UNITED STATES PATENT AND TRADEMARK OFFICE

APPLICATION NO.	FILING DATE	FIRST NAMED INVENTOR	ATTORNEY DOCKET NO.	CONFIRMATION NO.
10/798,422	03/12/2004	Seiji Horino	Q79112	6553
23373 7590 01/25/2007 SUGHRUE MION, PLLC 2100 PENNSYLVANIA AVENUE, N.W. SUITE 800 WASHINGTON, DC 20037			EXAMINER ROJAS, OMAR R	
			ART UNIT	PAPER NUMBER
			2874	
SHORTENED STATUTORY PERIOD OF RESPONSE		MAIL DATE	DELIVERY MODE	
3 MONTHS		01/25/2007	PAPER

Office Action Summary

DETAILED ACTION

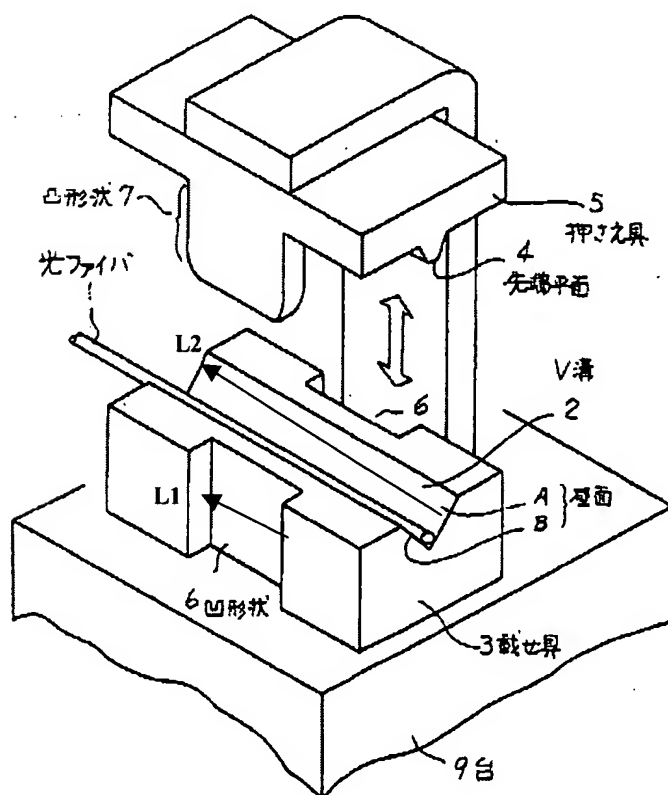
With respect to the Parat reference, applicant(s) essentially argue that "*Parat* does not disclose a protrusion which is substantially perpendicular to the direction of the groove of the body, thus, independent claim 1 patentably distinguishes over the prior art". See page 13 of the Response. However, the protrusion 10 of Parat (see Fig. 14 of Parat) has a thickness "H4" which extends in a downward direction (i.e., in the direction of the double arrows shown in Fig. 14). This direction is clearly perpendicular to the direction of the groove holding the optical fiber 2. Thus, Parat does, in fact, disclose a protrusion 10 that is substantially perpendicular to the direction of the groove of the body 66.

FIG. 14

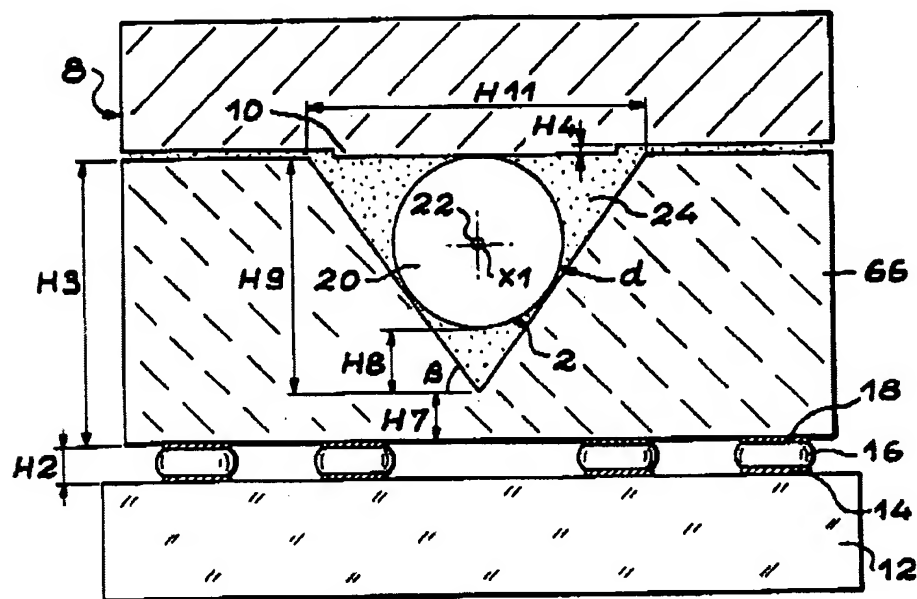
In re claim 1, Parat discloses in Figure 14, an optical fiber fixing system for fixing an optical fiber comprising:

a fixing body 66 comprising a first groove, formed in a top surface thereof, extending in a first direction to support the optical fiber 2 along its axial direction; and

a pressing body 8 comprising a protrusion 10, formed on a bottom surface thereof, and extending substantially perpendicularly to the direction of the first groove, wherein the bottom

surface of the pressing body 8 faces the top surface of the fixing body 66. Figure 14 of Parat is reproduced below.

In re claim 2, the bottom surface of the pressing body 8 and the top surface of the fixing body 66 are substantially planar.

In re claim 4, the cross section of the first groove is V-shaped as seen in Figure 14.

In re claim 29, the pressing body 8 is movable towards the fixing body 66 so that the optical fiber 2 is fixed therebetween by the protrusion 10 pressing the optical fiber 2 against the first groove (col. 11, lines 53-55).

Figure 13 of Sherrer is reproduced below.

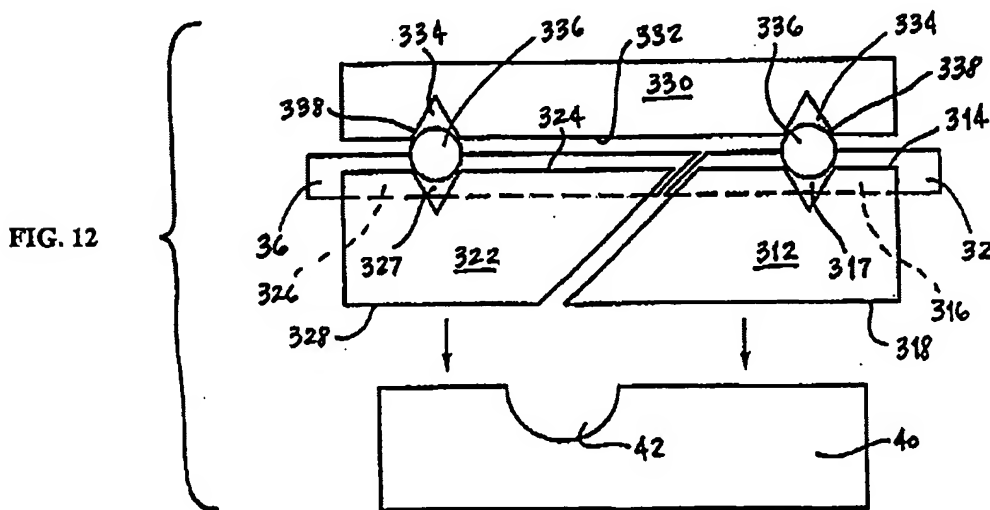
In re claim 1, Sherrer discloses in Figures 12-13, an optical fiber fixing system for fixing an optical fiber comprising:

a fixing body 322 comprising a first groove 326, formed in a top surface 324 thereof, extending in a first direction to support the optical fiber 36 along its axial direction; and

a pressing body 330 comprising a protrusion 336, formed on a bottom surface 332 thereof, and extending substantially perpendicularly to the direction of the first groove 326, wherein the bottom surface 332 of the pressing body faces the top surface 324 of the fixing body.

In re claim 2, the bottom surface 332 of the pressing body 330 and the top surface 324 of the fixing body 322 are substantially planar.

In re claim 3, when the optical fiber 36 is supported in the first groove 326, a ridgeline of the optical fiber 36 protrudes out of the first groove above the top surface 324 of the fixing body 322.

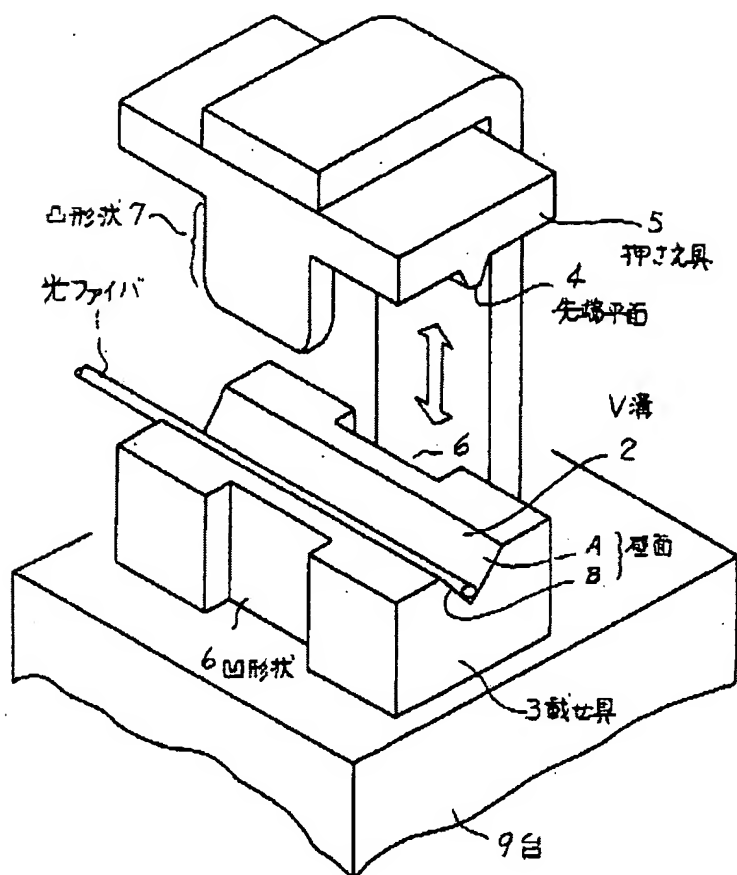
In re claim 4, the cross section of the first groove 326 is inherently V-shaped because a V-shape is considered a well-known conventional shape to use in order to hold optical fibers.

In re claim 18, the protrusion 336 is arranged in a precision mounting groove 334 formed in the bottom surface 332 of the pressing body 330. The protrusion 336 is inherently formed of a material different from that of the pressing body 330 because there are only two possible alternatives (i.e., they are both either formed of the same material or of a different material).
